REMARKS

Title: Differential and Differential Case Inventors: WATANABE et al. et al. App. No.: 10/780,587 Docket No.: 023971-0377

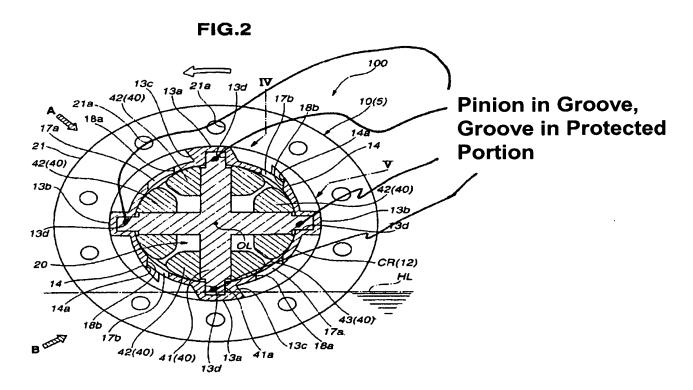
Claim 1 recites a differential for a wheeled motor vehicle that includes, as distinguishing features from Porsche, "first projected portions formed on an outer surface of the differential case at portions that support . . . *pinion shafts through . . . grooves*," where, as is earlier recited in claim 1, the "grooves [are] for respectively receiving therein the pinion shafts." In an exemplary embodiment of the present invention, as is depicted in Fig. 2, the

first projected portions 13a are formed at portions that support the pinion shafts (see the radially leading ends of pinion shafts of the pinion shaft unit 41, which protrude into cavities (grooves 13d) of the first projected portions). Below is an annotated reproduction of Fig. 2 from Applicants' application, which clearly shows the cavities (grooves 13d) in the projected portions.

FIG.4(B)

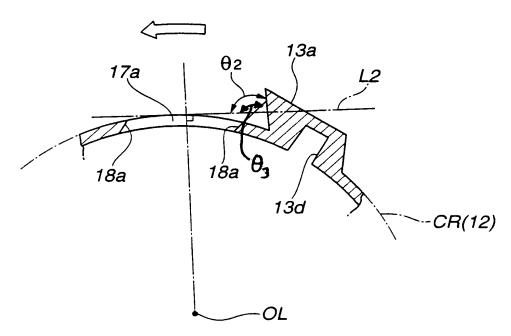
In the November Office Action, the drawings were objected to as allegedly failing to show every feature present in the claims.

The amendment to Fig. 4(B) introduces the angle symbol along with the identifier " θ_3 ", and clearly identifies an obtuse angle as defined by the angle between surface 18a and the tangential line L2.

In response, in order to advance prosecution, and without prejudice or disclaimer, Applicants have amended Fig. 4(B) as shows above, and also amended claim 9 as show above, and request reconsideration.

Applicants have amended the specification, as seen above, to comport with the amendment to Fig. 4(B).
